NOTICE OF ALLOWANCE AND FEE(S) DUE

APPLICATION NO.	FILING DATE	FIRST NAMED INVENTOR	ATTORNEY DOCKET NO.	CONFIRMATION NO.
13/284 674	10/28/2011	Esat Yilmaz	080900 0647	7554

TITLE OF INVENTION: FLEXIBLE TOUCH SENSOR

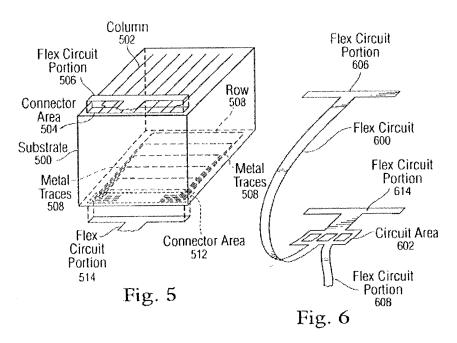
The Office Action points to Figures 1, 2a, and ¶¶ 30-33 of Hotelling as allegedly teaching the emphasized portion of Claim 1 above. Office Action p. 4. However, in contrast to drive or sense electrodes made of flexible conductive material configured to bend with the substantially flexible substrate, Hotelling merely discloses that "a single flex circuit can be fabricated to connect to the rows and columns on directly opposing sides at the same edge of the substrate." Hotelling at ¶ 30. Requiring an additional flex circuit to connect rows and columns on opposite sides of a substrate does not disclose "drive or sense electrodes made of flexible conductive material configured to bend with the substantially flexible substrate," as recited by Claim 1.

Furthermore, at no point does *Hotelling* disclose sense traces or drive electrodes that "bend with the substantially flexible substrate" because at no point does *Hotelling* disclose a flexible substrate. This deficiency of *Hotelling* is reinforced in Figures 5 and 6:

Fig. 2

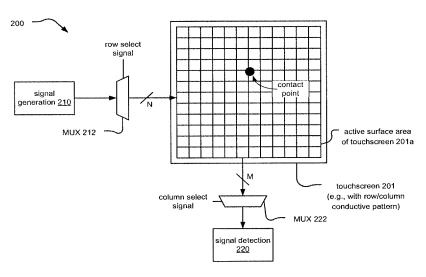
(Gray, Fig. 2 and ¶ [0063], emphasis added.) That is, while the cited portion of Gray may disclose row and column conductors disposed on the same layer, Gray is clear that the row and column conductors "do not directly come into contact" with each other. This is a different approach from "a touch sensor disposed on the substantially flexible substrate, the touch sensor comprising drive or sense electrodes made of flexible conductive material configured to bend with the substantially flexible substrate, wherein the flexible conductive material of the drive or sense electrodes comprises first and second conductive lines that electrically contact one another at an intersection," as recited in Claim 1 (emphasis added). Thus, the cited portions of Gray do not disclose, teach, or suggest each and every element of amended Claim 1. Consequently, because the Office Action admits that neither Grant nor Hotelling cure these deficiencies of Gray, the proposed Grant-Hotelling-Gray combination fails to disclose, teach, or suggest each and every element of amended Claim 1.

Fig. 7

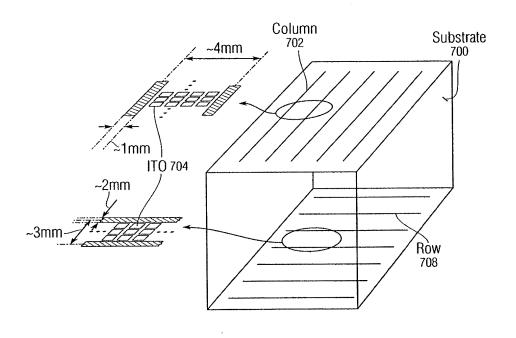
(Hotelling, ¶¶ [0035]-[0036] and figure 7, emphasis added.) That is, Hotelling discloses row and column traces on two different sides of a dielectric that "do not make direct electrical contact with each other," a different approach from "a touch sensor disposed on the substantially flexible substrate, the touch sensor comprising drive or sense electrodes made of flexible conductive material configured to bend with the substantially flexible substrate, wherein the flexible conductive material of the drive or sense electrodes comprises first and second conductive lines that electrically contact one another at an intersection," as recited in amended Claim 1. The cited portions of Grant do not appear to cure these deficiencies of Hotelling, and the Final Office Action does not appear to allege that they do. Consequently, the proposed Grant-Hotelling combination fails to disclose, teach, or suggest each and every element of amended Claim 1.
